## Permit Modification Request

The following submittal has been prepared by the Department of Energy and Los Alamos National Security, LLC (DOE/LANS) to request eleven (11) permit modifications to the November 2010 Los Alamos National Laboratory (LANL) Hazardous Waste Facility Permit (Permit). These modifications have been prepared as self-implementing Class 1 permit modifications and Class 1 permit modifications requiring prior approval as described in the New Mexico Administrative Code, Title 20, Chapter 4, Part 1 (20.4.1.900 NMAC) (incorporating Code of Federal Regulations [CFR], Title 40 § 270.42(a) and (d)). LANL's Environmental Protection Agency (EPA) identification number is EPA ID No. NM0890010515.

The permit modifications include changes to the emergency equipment listings and instructions for inspections, revisions to figures and descriptions of structures and equipment at Technical Areas (TA) 50 and 54, and correction and clarification of statements within the existing Permit to reflect various changes occurring in support of waste management activities. These modifications do not include requests to remove any emergency equipment without replacement, changes to the ca

**Figure G.5-1: Technical Area (TA) 50, Building 69, Outdoor Container Storage Unit Sample Grid and Additional Sampling Locations**

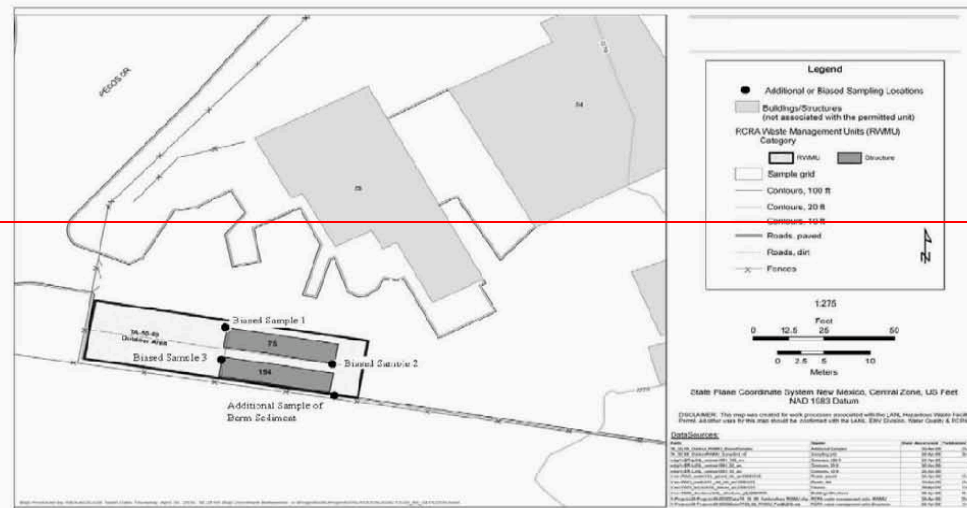
The figures currently within the Permit incorrectly identify one of the transportainers at the TA-50-69 Outdoor Unit as structure number 154. Figure 23 within Attachment N (*Figures*) and Figure G.5-1 within Attachment G.5 (*TA-50-69 Outdoor Container Storage Unit Closure Plan*) have been revised to correctly identify this structure as 194. The purpose of this permit modification makes an informational changes and is being implemented as a Class 1 permit modification pursuant to 40 CFR § 270.42(a).

Figure G.6-1: Technical Area 54, Area G, Pad 1 Outdoor Container Storage Unit Grid Sampling Locations

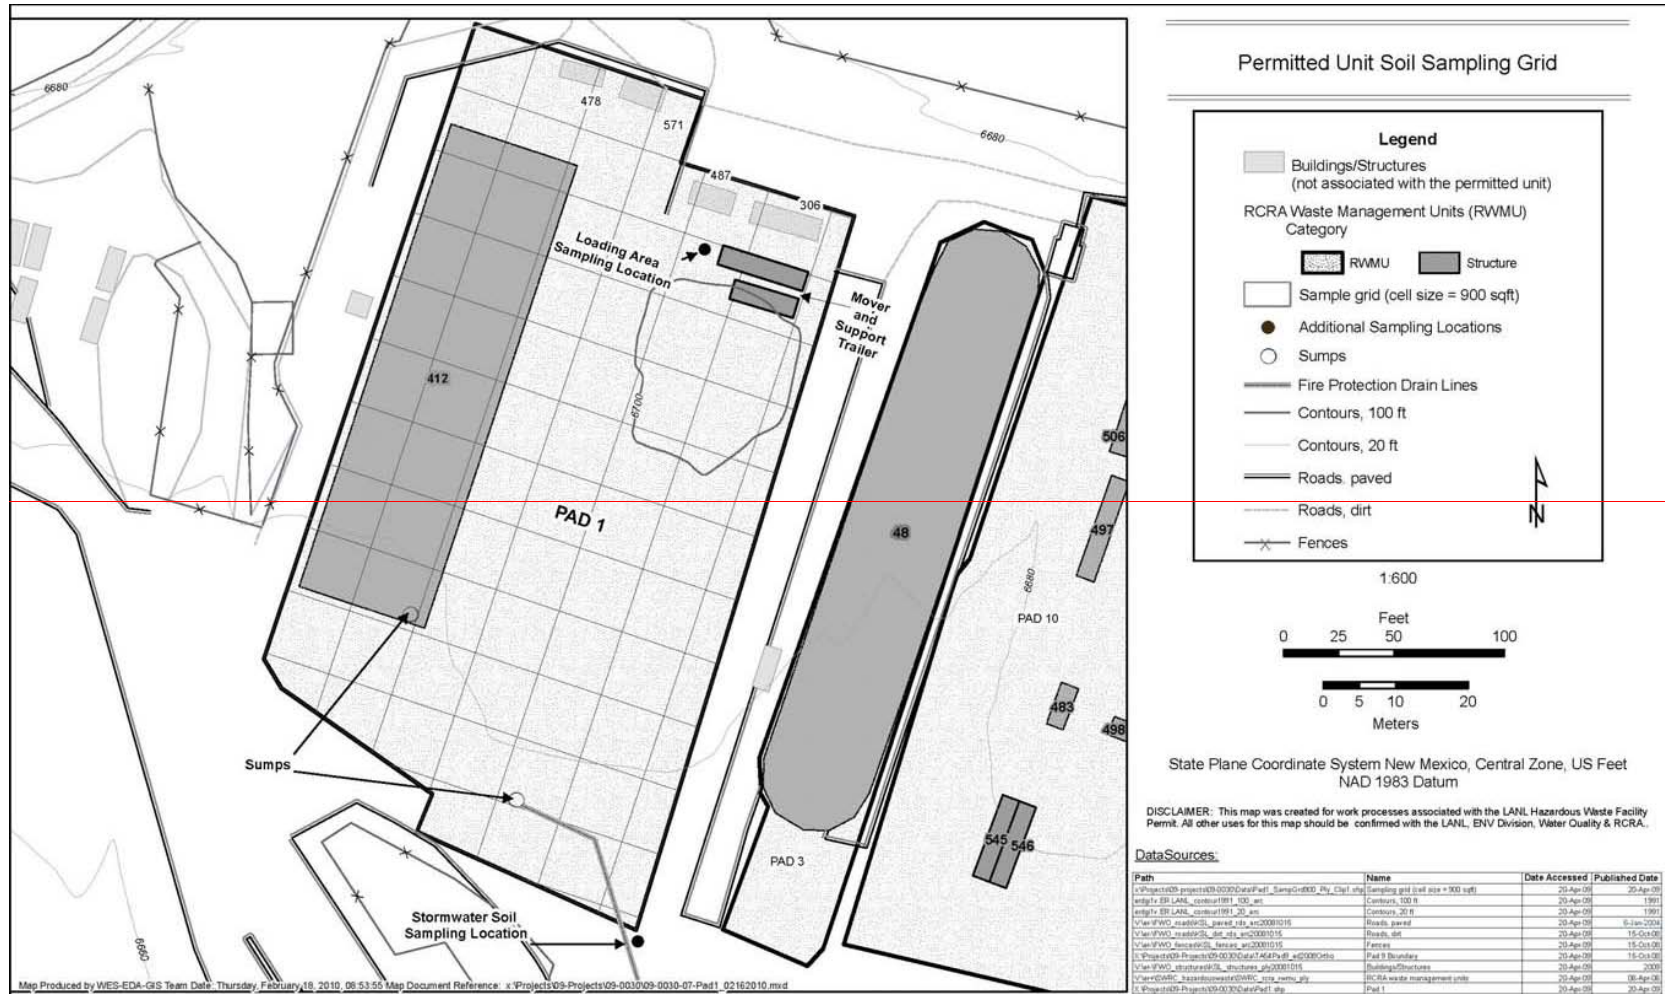
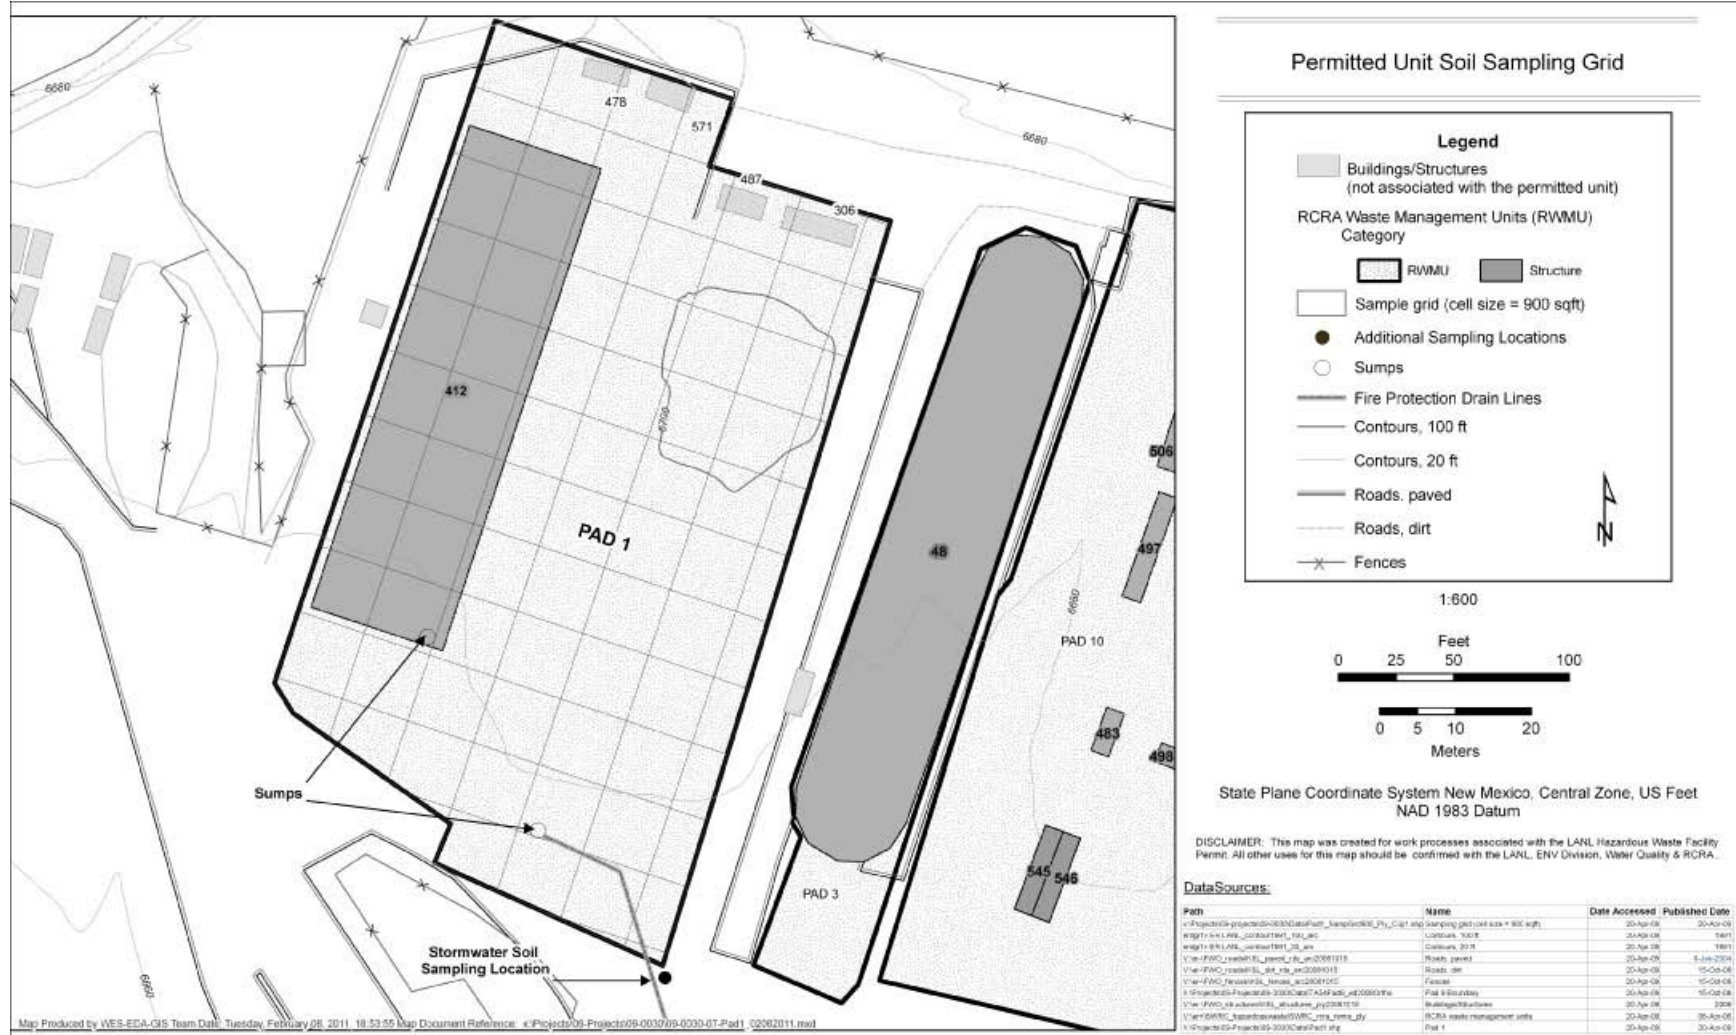
The Mobile Visual Examination and Repackaging (MOVER) trailer and support trailer was approved to be installed on Pad 1 in March 2010. The trailer was meant to be used to support transuranic waste characterization procedures, but was never installed. The purpose of this permit modification is to remove the MOVER trailer and support trailer from the Figures 8, 27, 29, and G.6-1 as well as the applicable language in Attachment G.6 (*TA-54, Area G, Pad 1, Outdoor Container Storage Unit Closure Plan*), Sections 2.0,

5.3.1, 5.3.2, and 6.1; and Attachment A (*TA- Unit Descriptions*), Section A.4.2.2. Additionally, changes have been made to Table J-1 within Attachment J (*Hazardous Waste Management Units*) to remove the MOVER and support trailer. The revisions described and illustrated in the redline-strikeout text, make administrative and informational changes to reflect that a planned structure was never installed on TA-54, Area G, Pad 1. This modification is being implemented as a Class 1 permit modification pursuant to 40 CFR § 270.42(a).

**Figure G.10-1: Technical Area 54, Area G, Pad 9 Outdoor Container Storage Unit Grid Sampling and Additional Sampling Locations**

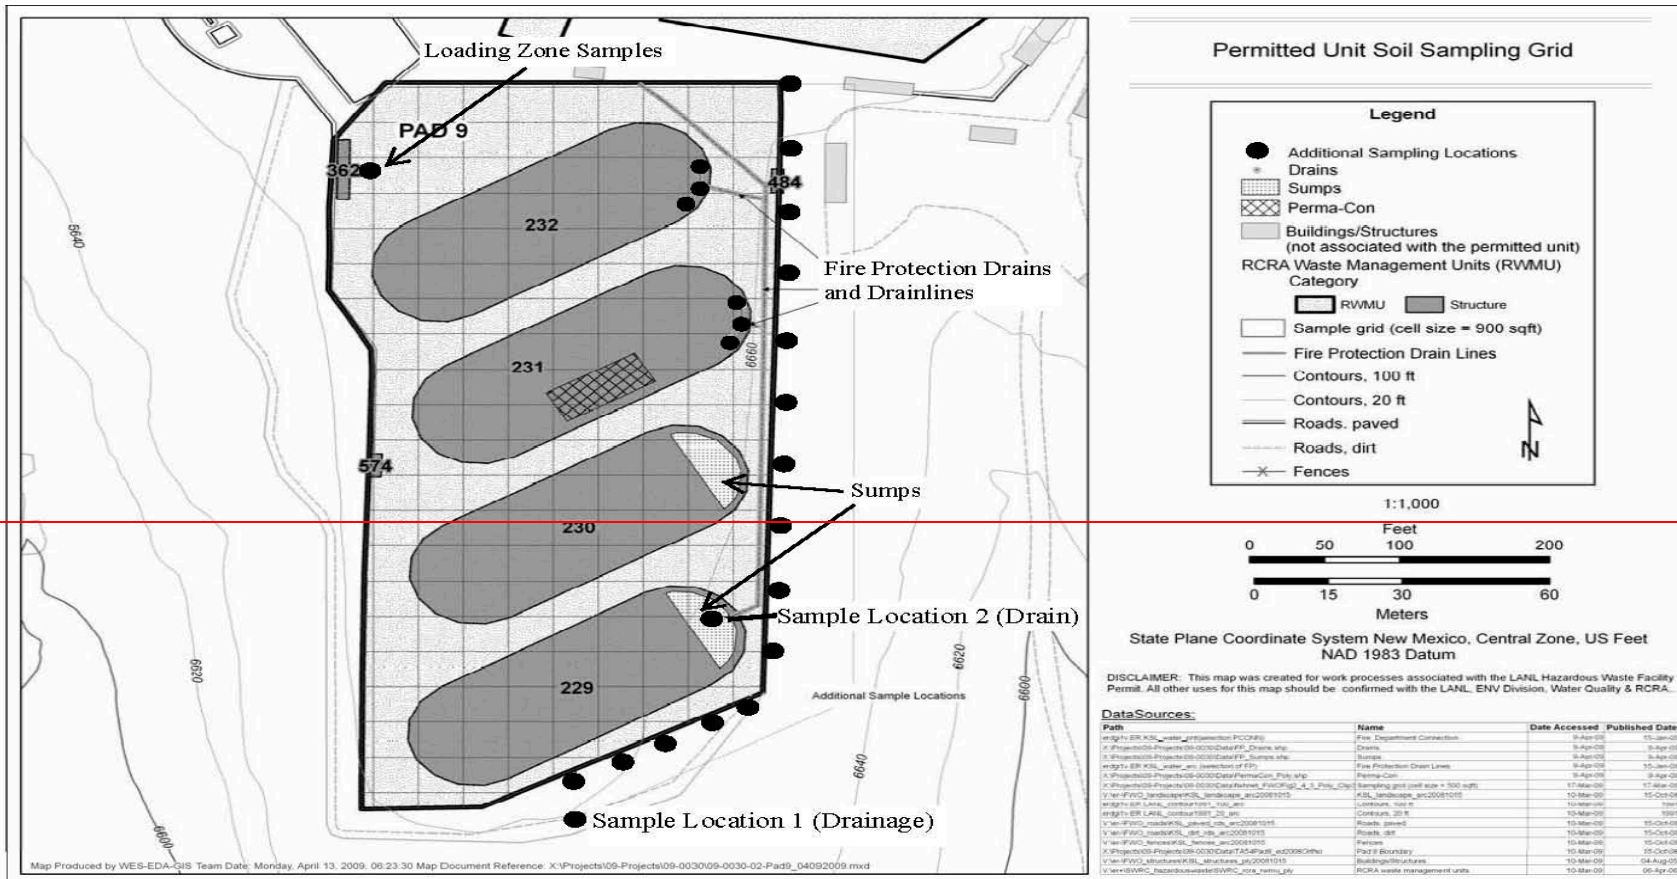
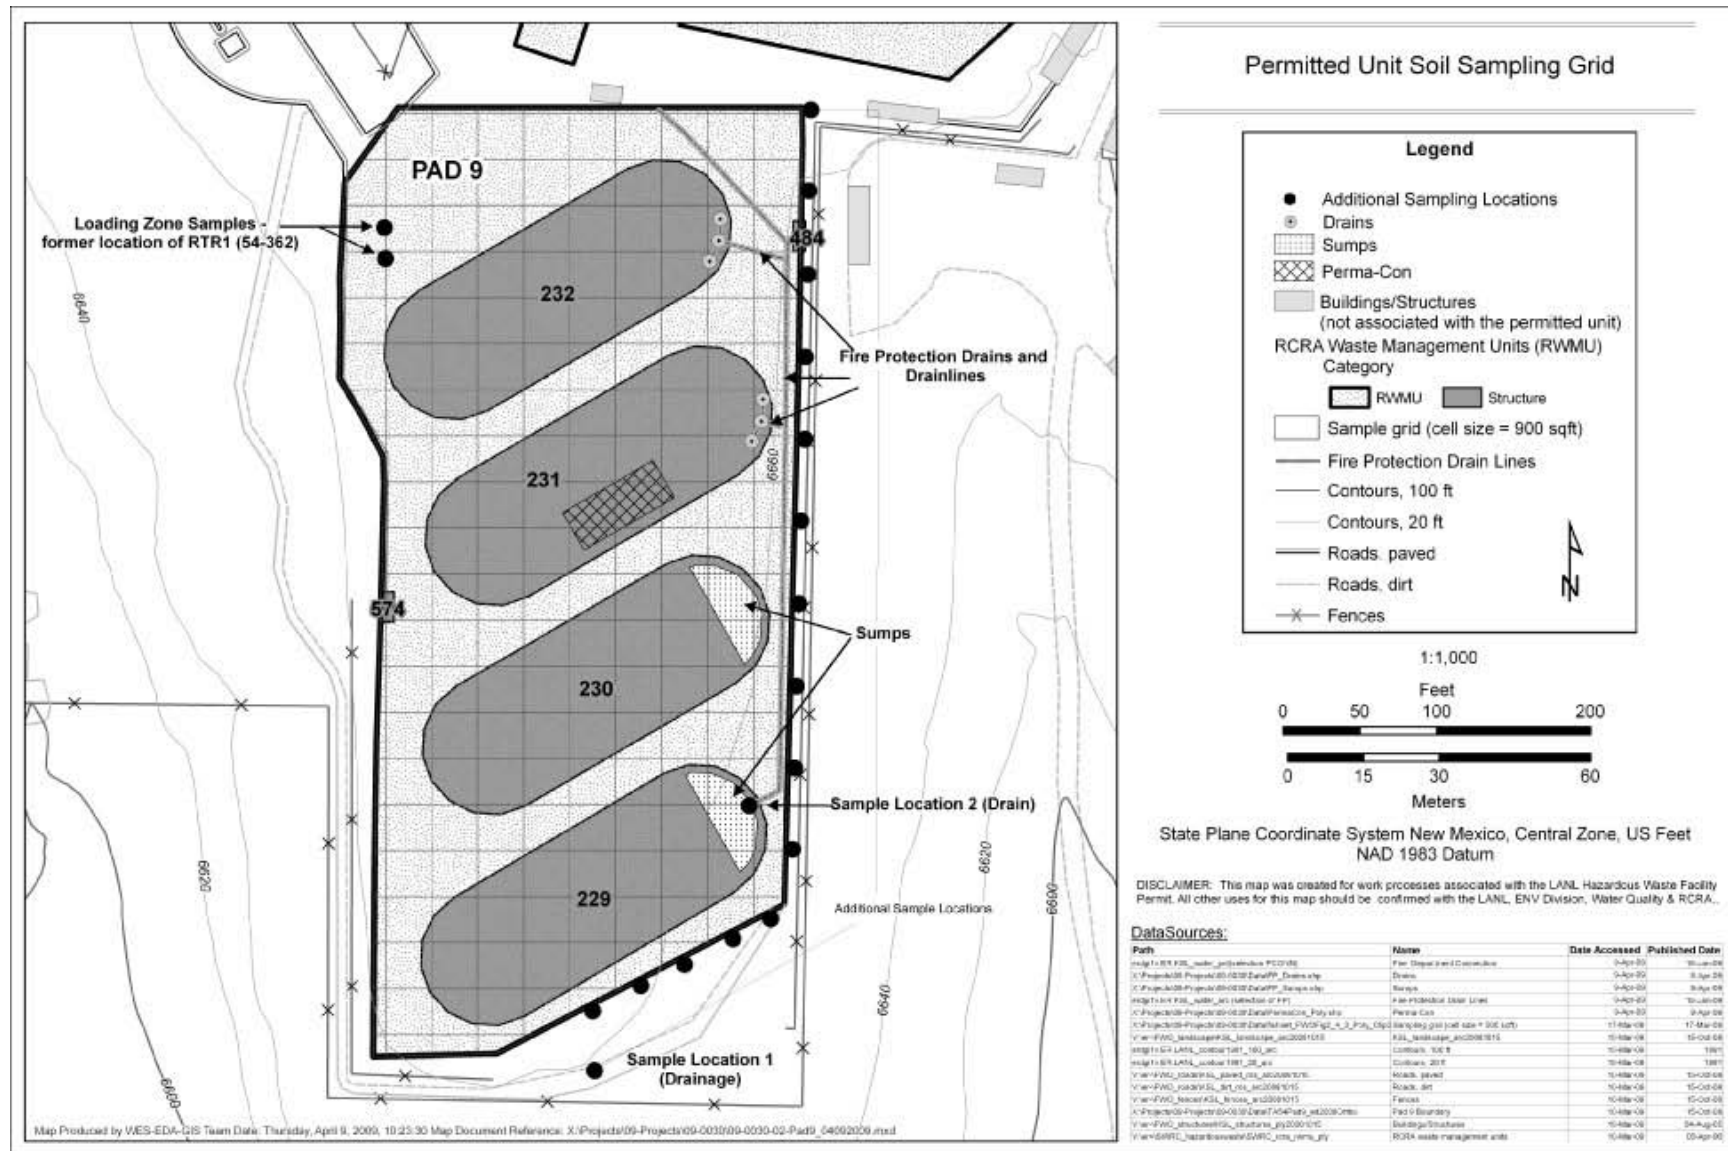
The Real-Time Radiography (RTR) system 1 is currently at TA-54, Area G, Pad 9 and is identified as transportainer 362 in Attachment G.10 (*TA-54, Area G, Pad 9 Outdoor Container Storage Unit Closure Plan*), Attachment J (*Hazardous Waste Management Units*), and Attachment N (*Figures*). The unit has been used in support of the transuranic waste characterization activities at TA-54. Plans to remove this unit from Pad 9 and relocate it to Pad 11 are underway. However, the trailer must be moved temporarily prior to being removed from TA-54, Area G, Pad 9. The RTR1 will move approximately 20 feet to the south and be used for waste characterization before it is removed from the pad entirely. Because the ultimate destination for the RTR1 is not on Pad 9, Sections 2.0, 2.1, 5.2.2, & 5.3.2 and Table G.10-6 within Attachment G.10 have been revised to remove structure 362 (transportainer) from the permitted units. Also, Section 6.1 and Figure G.10-1 within Attachment G.10 have been revised to remove the structure, but two sampling points will remain for the purpose of closure. There will be a sampling location representing loading operations for the original location of the RTR1 and one to indicate the second location of the RTR1. Table J-1 within Attachment J has been revised to remove “Transportainer 362” from the TA-54 Area G Pad 9 description. Figures 8, 27, and 28 in Attachment N have been revised to remove structure 362 because it is the final state of the trailer. The purpose of this permit modification is to make changes to structures. Therefore, a Class 1 modification requiring prior Agency approval pursuant to
